ADDENDUM NUMBER THREE

B30-11

HALL STREET WASTEWATER TREATMENT FACILITY ROOF REPAIR

8
 A1
FLASHING DETAIL
 SCALE: 3" = 1'-0"

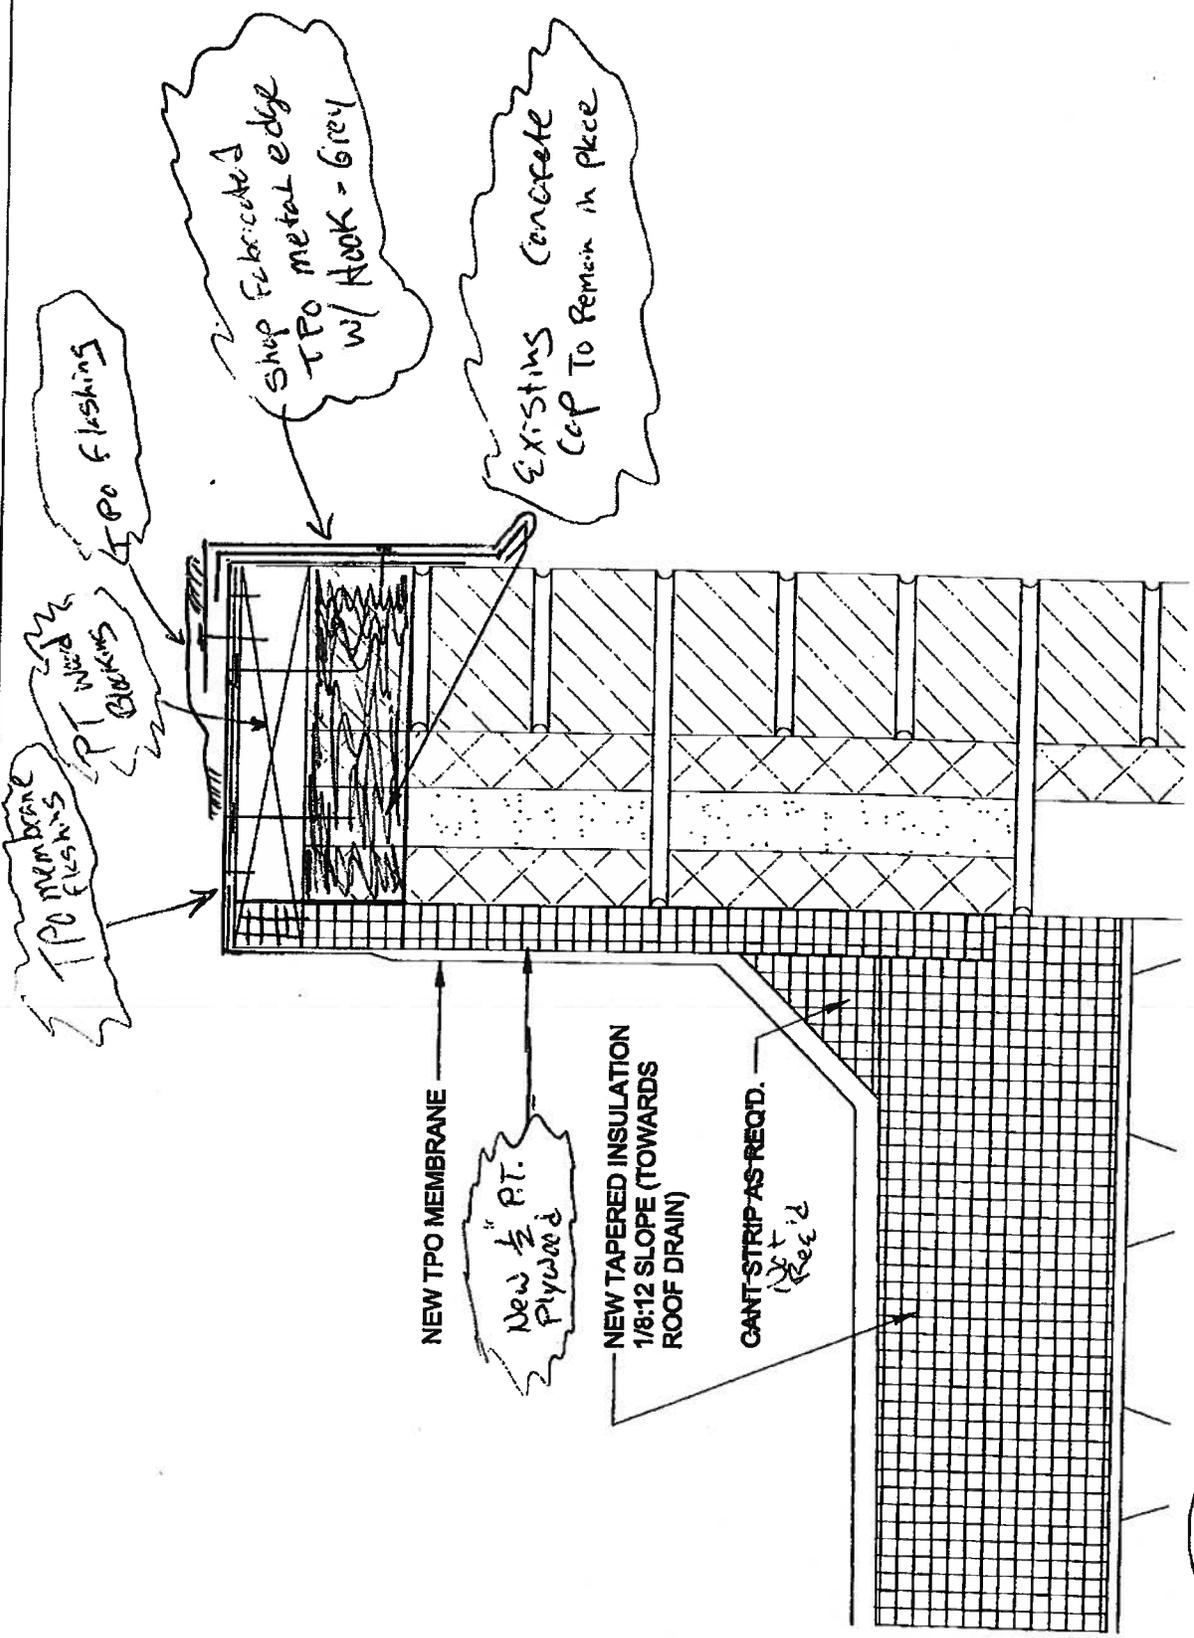
4. **Question.** Detail, 4/A2 on A1 and 2/A2 on A2 shows removal of existing concrete cap and pouring new grout filler in the first two blocks solid. This removal could cause significant structural damage to the existing parapet wall. Would you allow existing concrete cap to remain in place with new PT wood blocking attached, as shown on attached revised detail 8/A1 utilizing 25 gauge laminated TPO grey metal custom fabricated roof edge? (all membrane flashing and metal edge in this detail would be covered under the manufacturers 20 year L&M warranty).

Proposed Revised Detail 5/18/11

Answer. Existing concrete cap is to be removed per details.
